AGENDA
PLANNING COMMISSION MEETING
Wednesday, January 6, 2021
7:00 P.M.
Maggie Osgood Library
70 N. Pioneer Street

- a. Land Use File 2019-04 – Sunset Hills Subdivision (Map 19-01-14-21, Tax Lot 05000)
 - Public Hearing
 - Commission Deliberation
 - Commission Decision
- b. Land Use File 2020-02 Property Line Adjustment – Map 19-01-14-24, Tax Lots 02200 and 02100
 - Public Hearing
 - Commission Deliberation
 - Commission Decision

TENTATIVE SUBDIVISION PLAN
SUNSET HILLS

SUNSET HILLS RESIDENTIAL SUBDIVISION

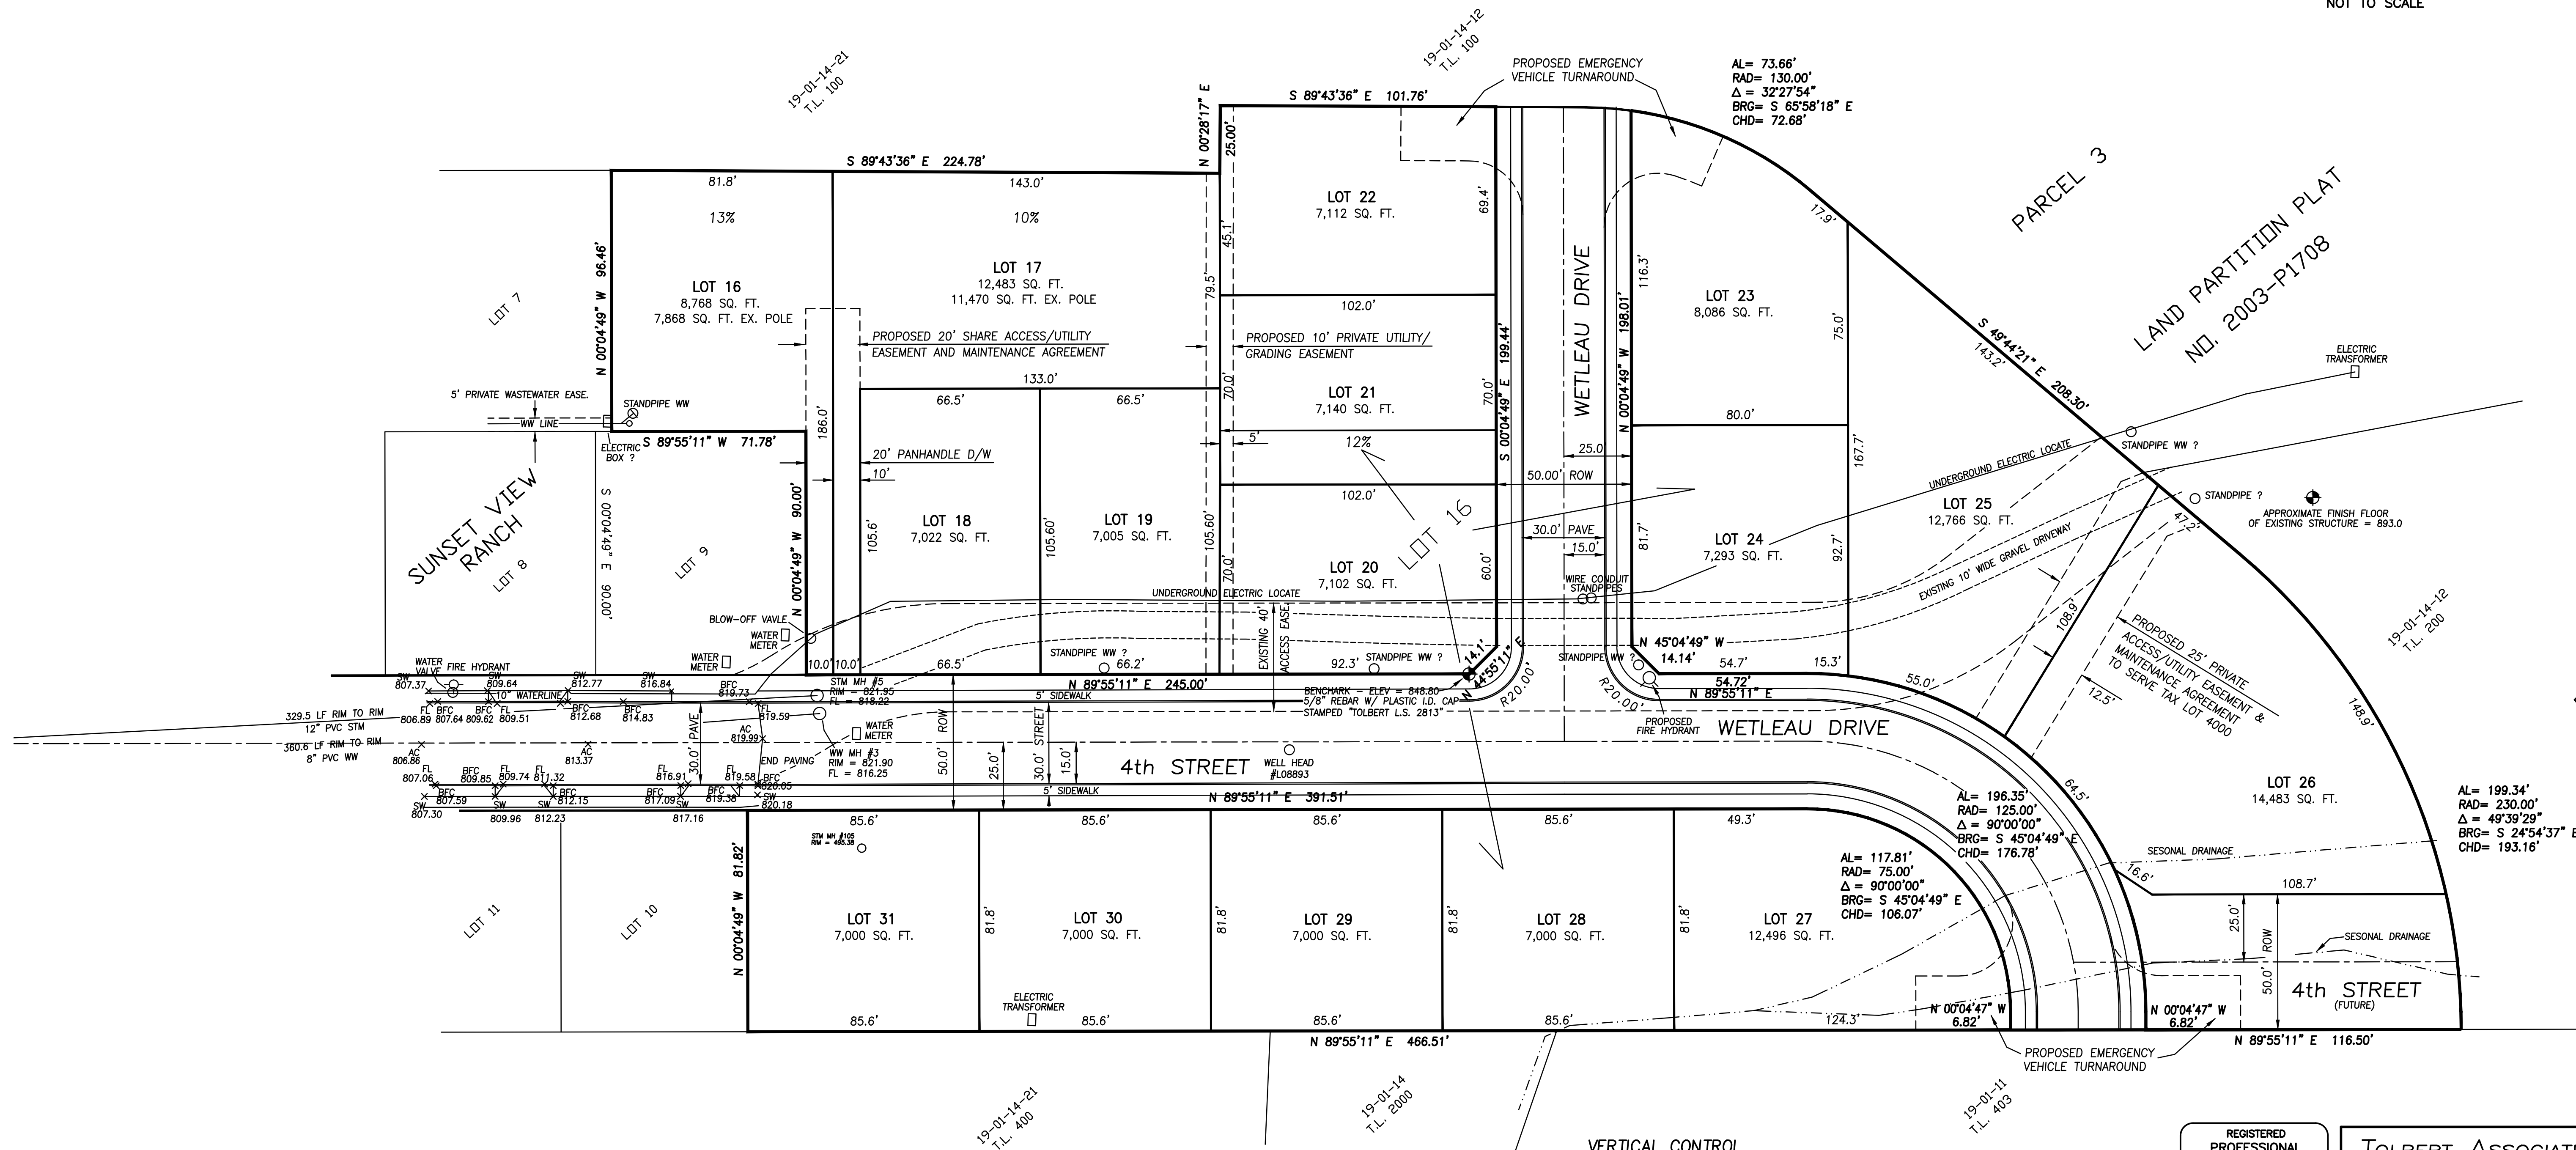
- The applicant submitted a revised Tentative Map to the City on December 7, 2020 (**Attachment B**). This revised map shows the applicant satisfying the previous condition of approval #2 as contained in the findings from the adjacent subdivision. This condition requires the future subdivider of the subject property to preserve future right of way access to lot 200. As seen on the new tentative map, the applicant has preserved 50-feet of ROW on the southern proportion of the property, abutting proposed Lot 26 and Tax Lot 403, for future public right of way. Public comment submitted by Ms. Mia Nelson on December 28, 2020 argues this section of preserved ROW must be improved to city standards by the applicant.

- The City Engineer has reviewed the revised tentative map, dated December 3, 2020. The City Engineer does not have any specific comments or concerns regarding the tentative map that need to be addressed by the applicant prior to tentative approval. However, the City Engineer's comments from July 2019 and December 29, 2020 remain and will be addressed between the City Engineer and the applicant's engineer, after tentative approval. The City Engineer will require detailed construction plans to be submitted and reviewed before any construction occurs.

Sheet 2 of 12 (Site Plan)

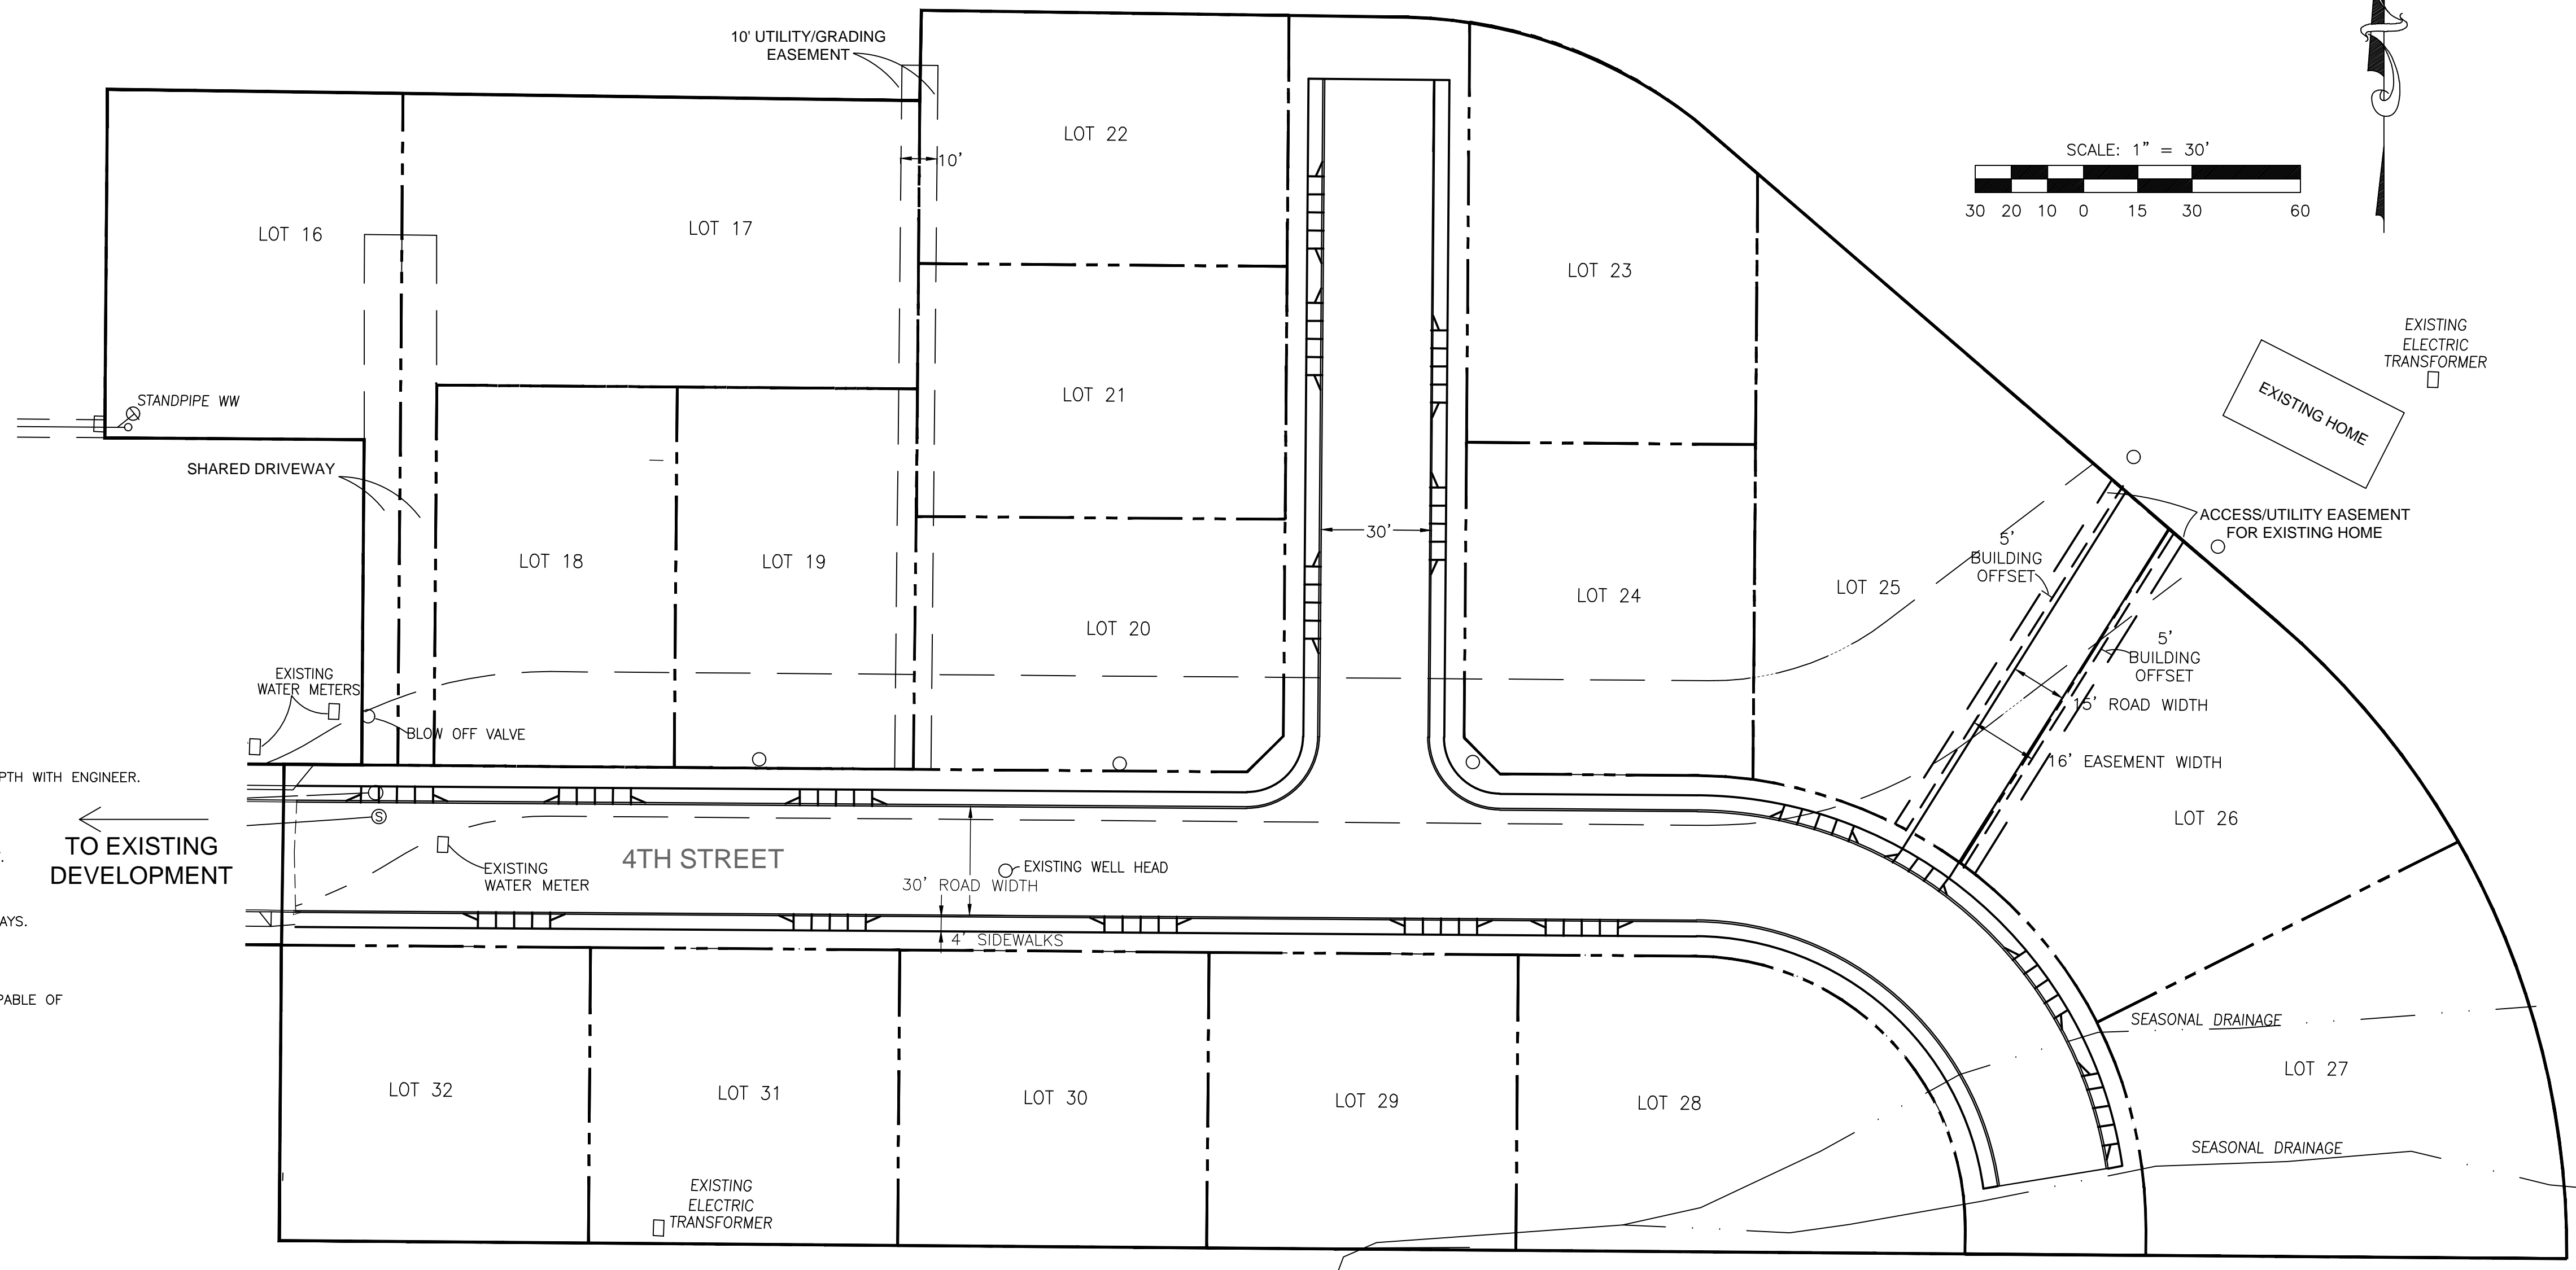
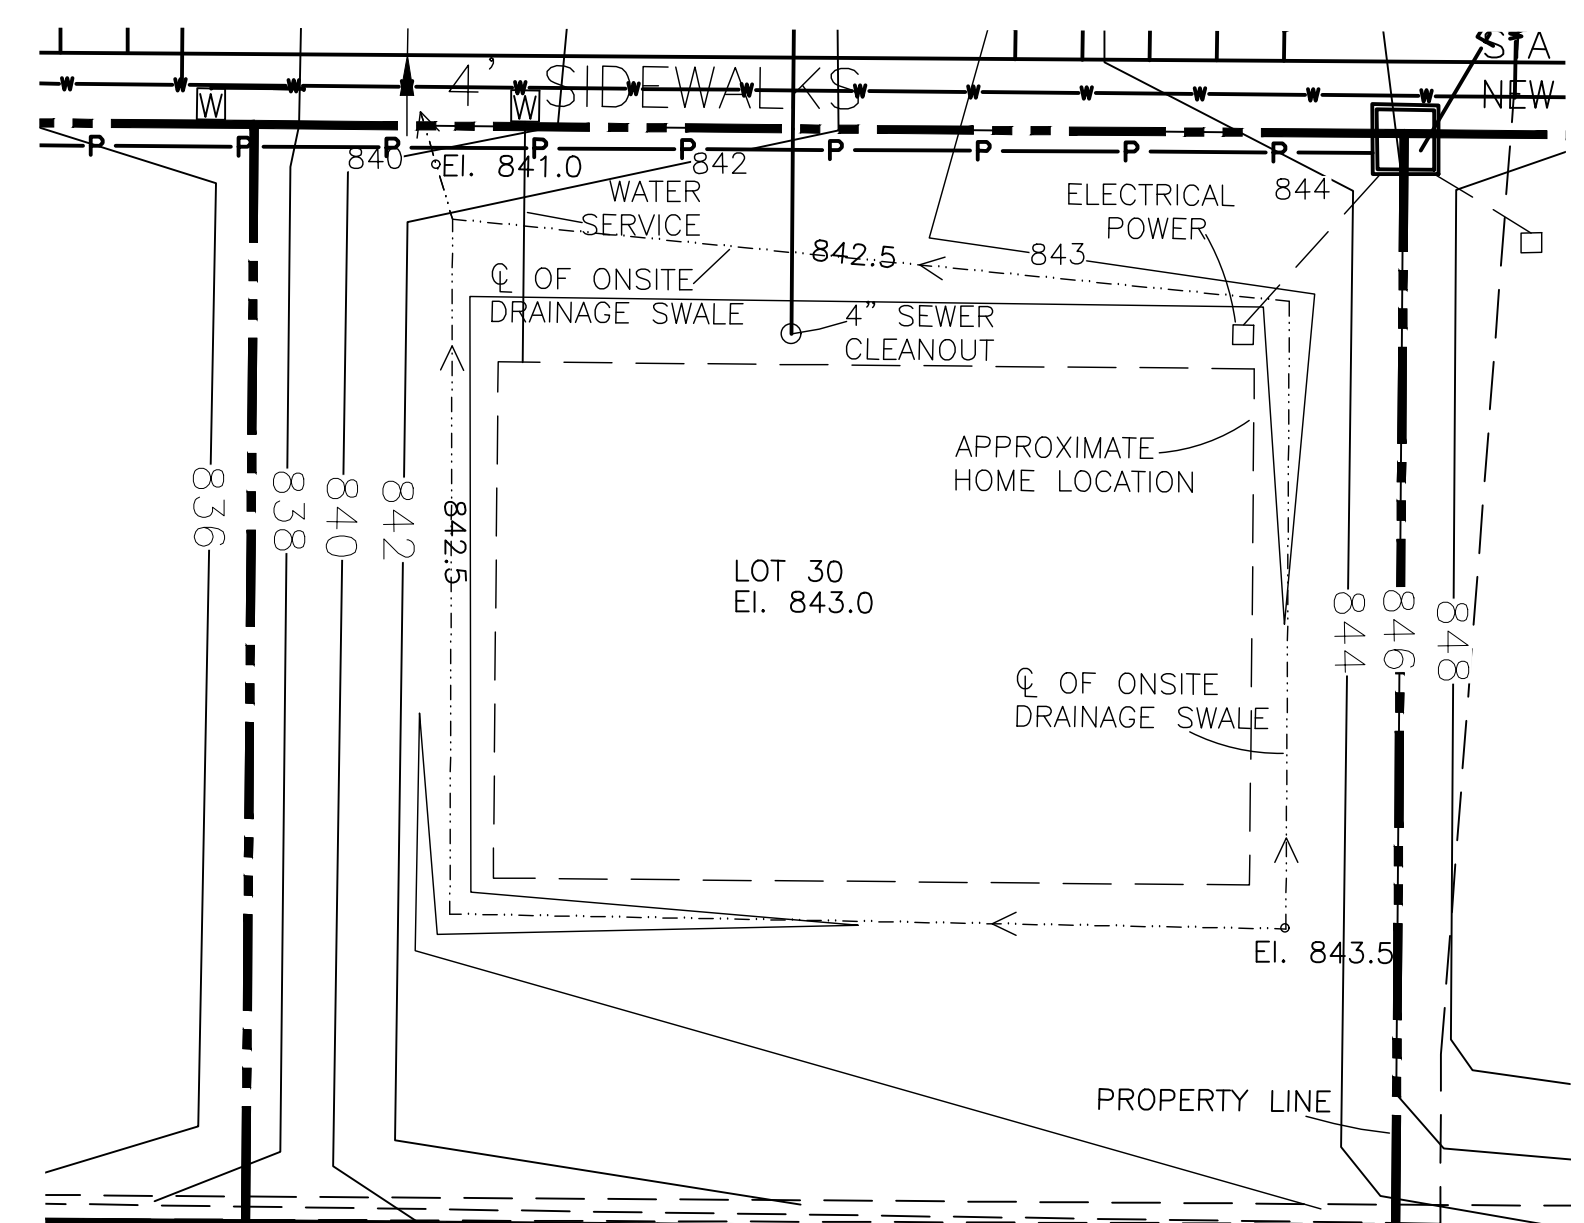
16. Please extend the window of the Typical Lot Drainage + Layout to show the sidewalk and driveway grades.
17. Drainage easements will be required wherever drainage from any lot drains onto, or across, any other lot. This would apply to lots 17, 19, 20, 21, 23, 27, 28, 29.
18. Label dashed line that runs through the site. Is this existing ROW?
19. Label north/south street.
20. Typical Street Section Detail; See Lowell Standard Detail 201 for local street detail, detail 202 for curb and gutter details, and 204 for sidewalk detail. Need an integral curb & gutter, base course should extend under curb, sidewalk should be a minimum of 5' wide, measured from back of curb.
21. Construction notes need to identify which detail they are referring to, rather than just the page.
22. Clarify on which lot the 16' easement to the existing house is on. Where is the PL?

4" CLEANOUT DETAIL NTS

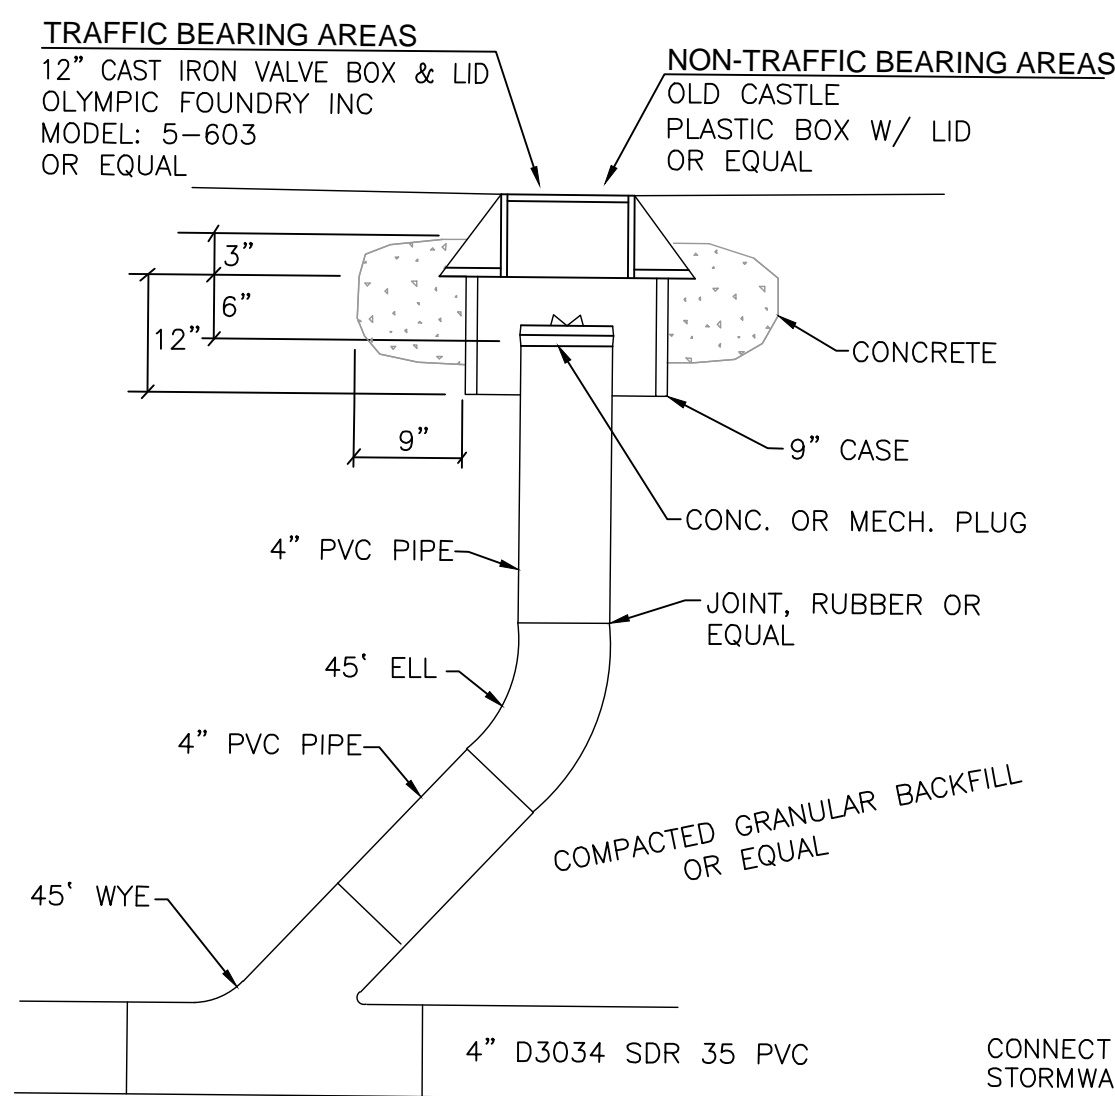
53. 4" cleanout detail should refer to SD 311 on sheet 8 for additional requirements.
54. 4" cleanout detail should show a temporary plug or cap in the lateral.
55. Custom Catch Basin Inlet #1 should have an access over the pipe. Access can be a vault style door, or a manhole. Blind connections are not allowed.
56. Sidewalk and Curb Drain detail. Provide calculations that show that a 12" x 3" tube will convey the peak stormwater beneath the sidewalk.
57. Sidewalk and Curb Drain detail. Provide reinforcement of concrete above the tube. At 2½" to 3" thick, the concrete will crack.
